NO.1 TRITON SQUARE

1.0 SUMMARY OF NMA's

NMA DESIGN REPORT

246868-A_A-XX-GF-DR-AX-30020 Ground Floor Plan

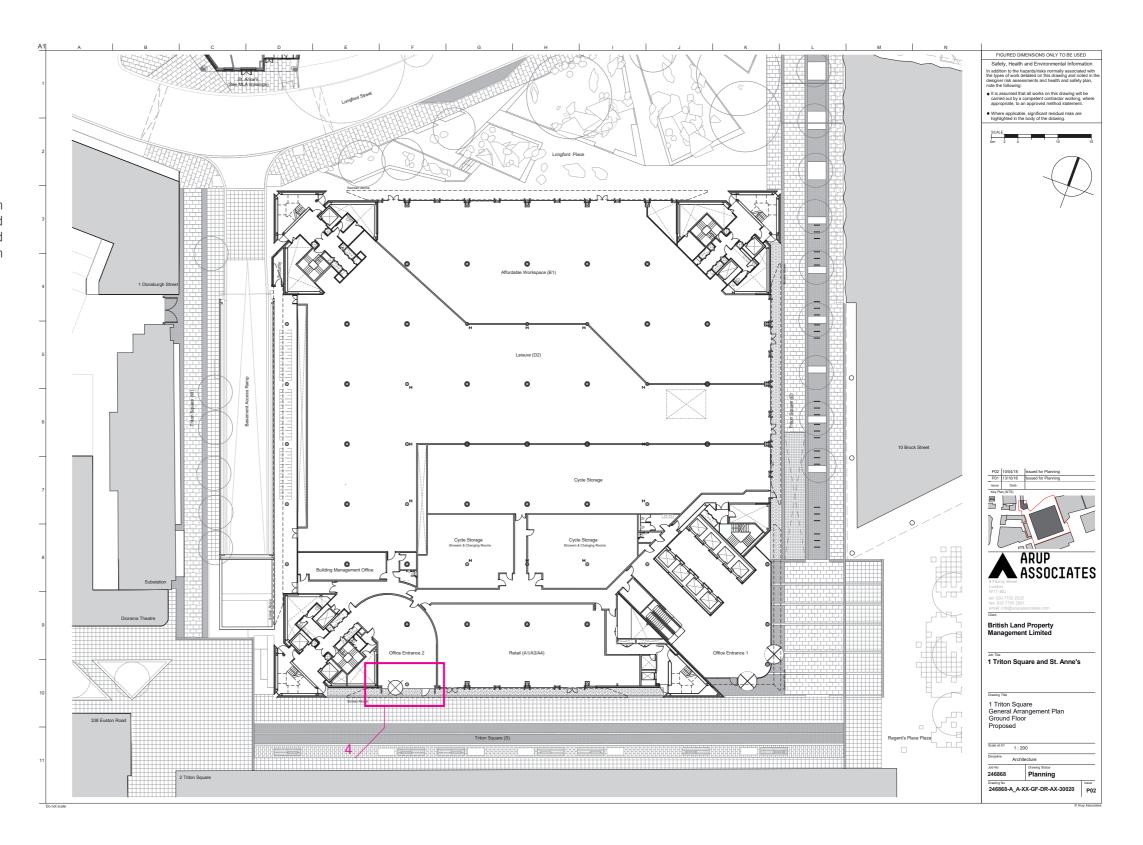
(4) The two portals of the SW Office Entrance have been combined into one double width portal. Depth increased from 300mm to 1000mm to enhance visibility as a second office entrance. Proportions and consistency of design approach maintained.

246868-A_A-XX-02-DR-AX-31002 Level 02 Floor Plan

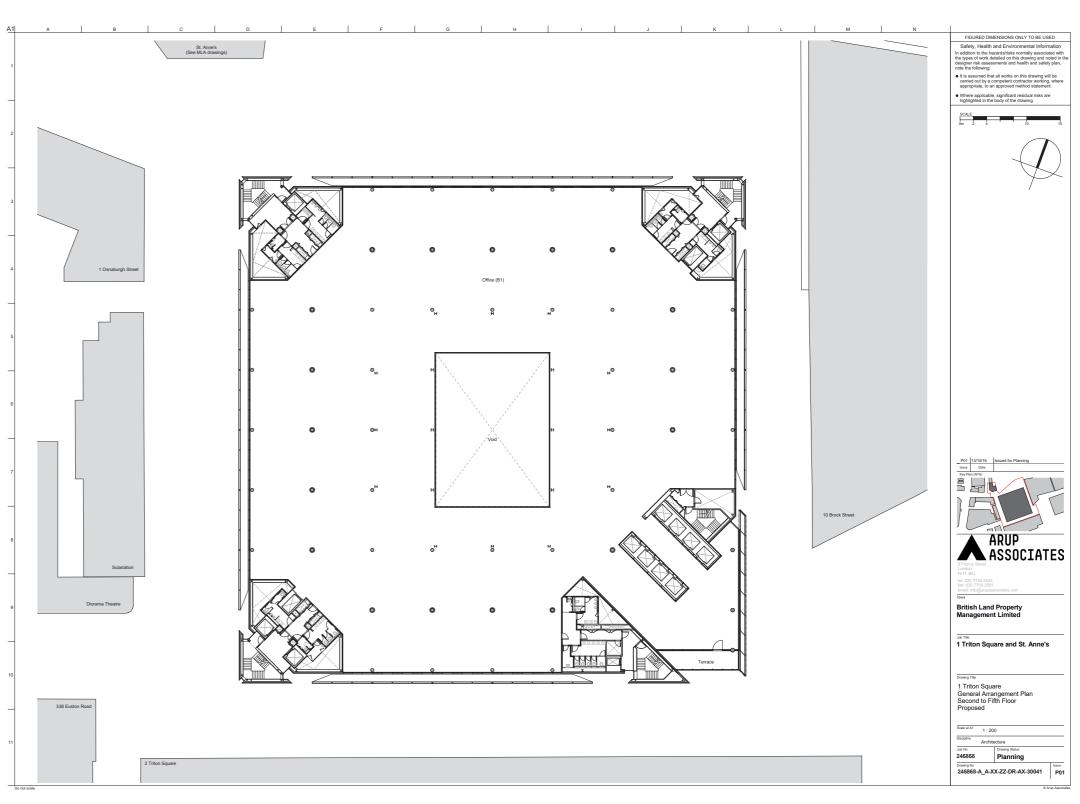
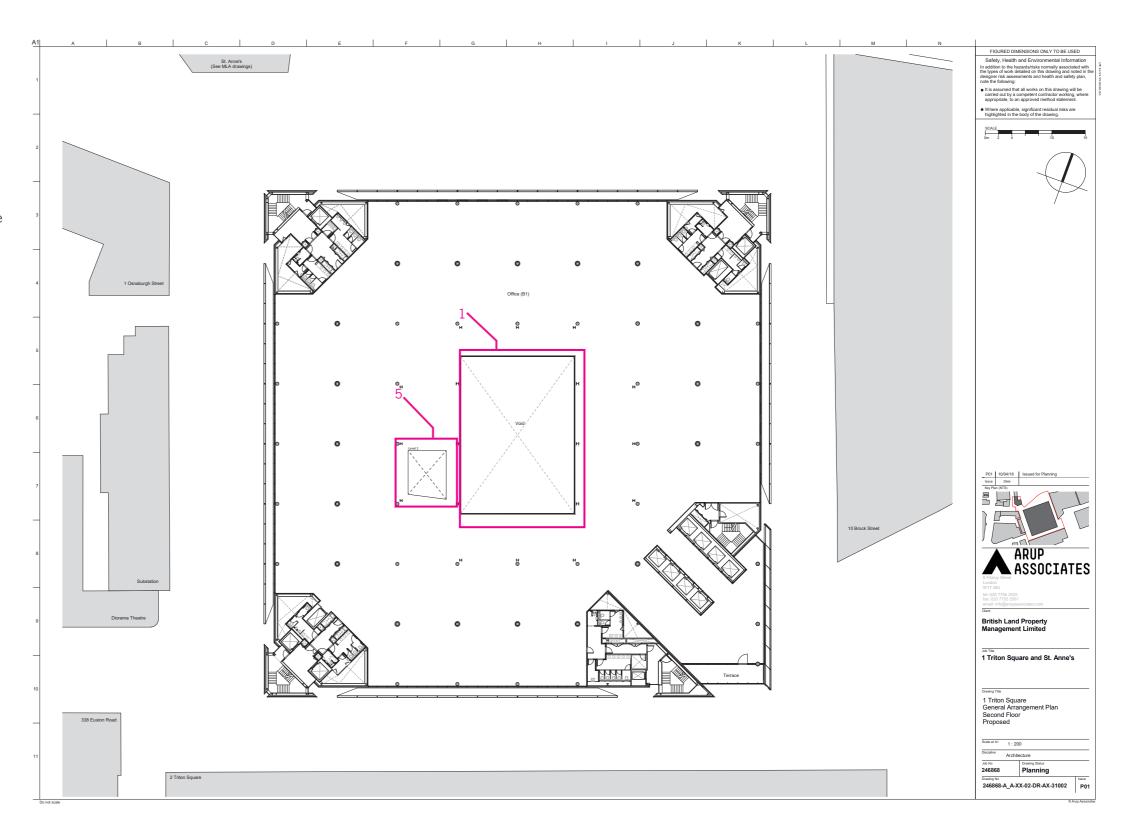
- (1) The incoming tenant has asked for a change to the atrium profile from vertically aligned balustrades to a profile that steps in and out. This shift is to the north and south sides of the atrium only.
- (5) Slab opening formed at Level 02, 03, 04 to accommodate internal stairs to be incorporated as part of tenant fit-out works.
